FW: 15 J-3 Cub Nose Block Key Extension

From: Tandy C. Walker [mailto:tandyw@flash.net]
Sent: Friday, September 28, 2007 3:08 PM
To: Walker, Tandy C. <tandyw@flash.net>
Subject: 15 J-3 Cub Nose Block Key Extension

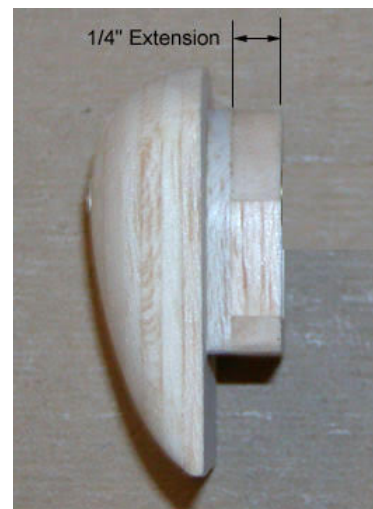
I received a note from Mike Midkiff this morning telling me that I should extend the 1/8" thick key on the back of the nose block another 1/4" around the perimeter to help hold the nose block in place. The picture below show the 1/4" extension that I added this afternoon at Mike's recommendation.

This picture shows the 1/4" extension in its entirety.
